Version 6

## Safety Recall: 2022-24 Civic Touring/Sport EPS Inspection (Service Parts)

Supersedes 23-085, dated November 1, 2023, to revise the information highlighted in **yellow**

- Under PARTS INFORMATION, a flange bolt was added.
- Under REPAIR PROCEDURE, steps 14 and 26 had images updated.

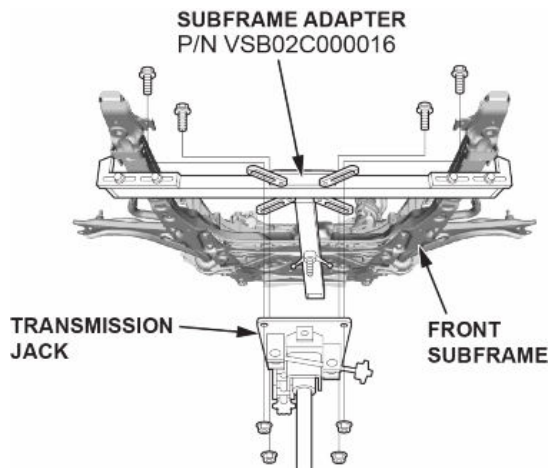
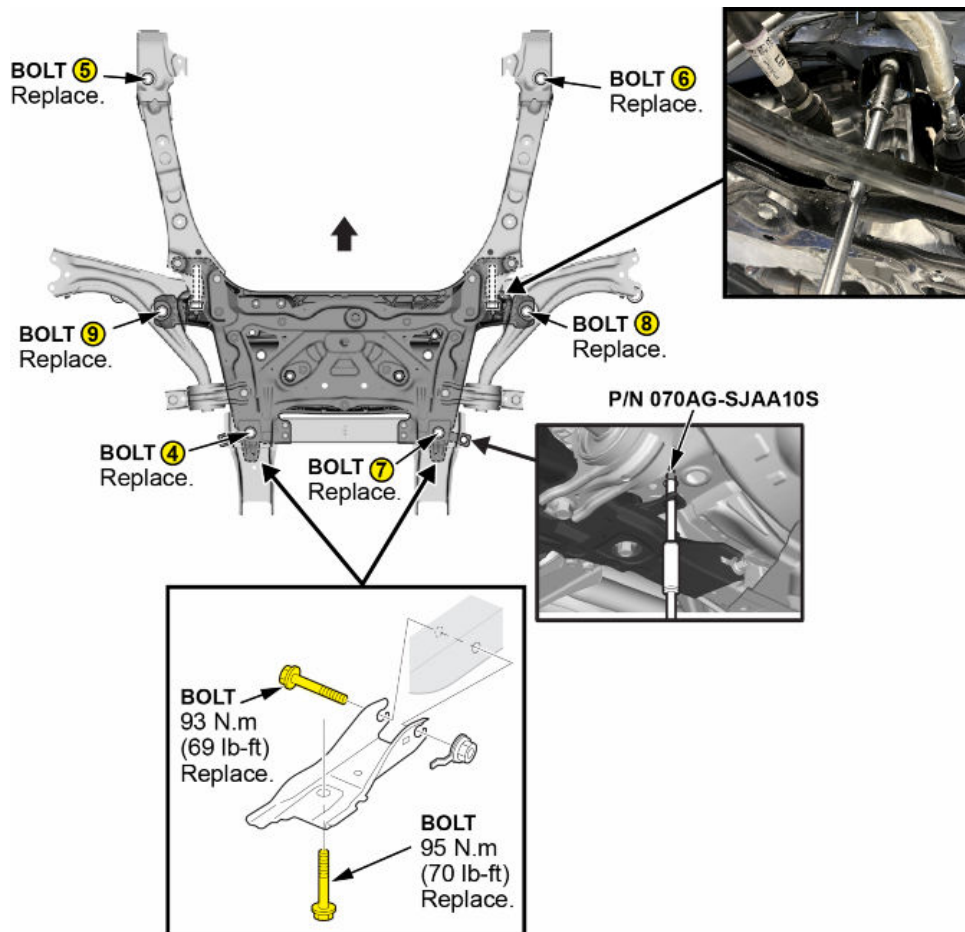
14. Raise a transmission jack and line up the slots in the subframe adapter arms with the bolt holes on the transmission jack base, then securely attach the four bolts. Then, remove the bolts highlighted in yellow only.

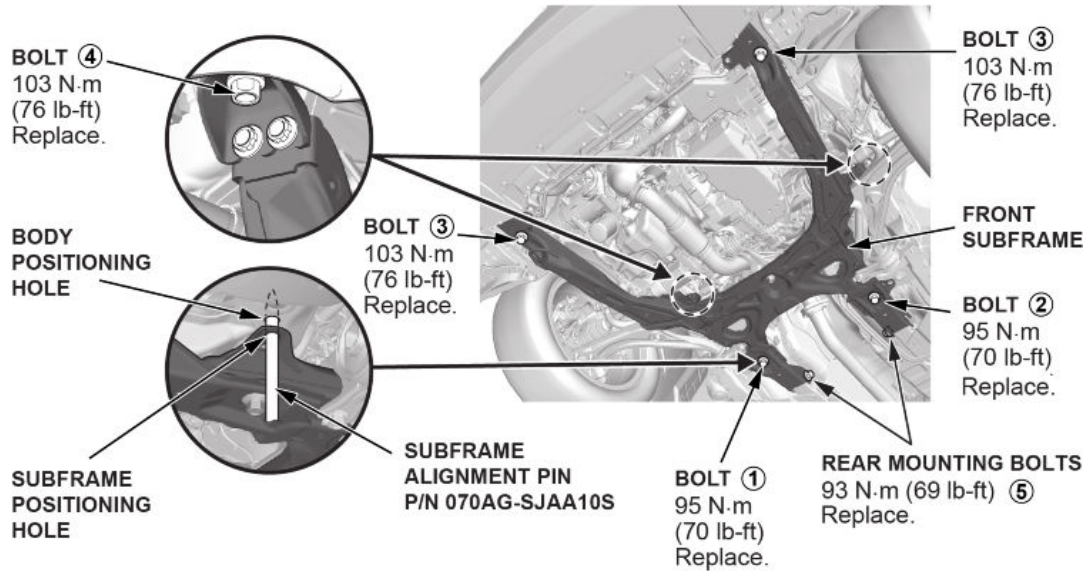
26. Raise a transmission jack and line up the slots in the sub frame adapter arms with the bolt holes on the transmission jack base. Loosely install the four bolts sub frame mounting bolts and the front subframe rear stay mounting bolts. Torque the front sub frame bolts **103 N·m (76 lb-ft)**, **95 N·m (70 lb-ft)**, **93 N·m (69 lb-ft)**.
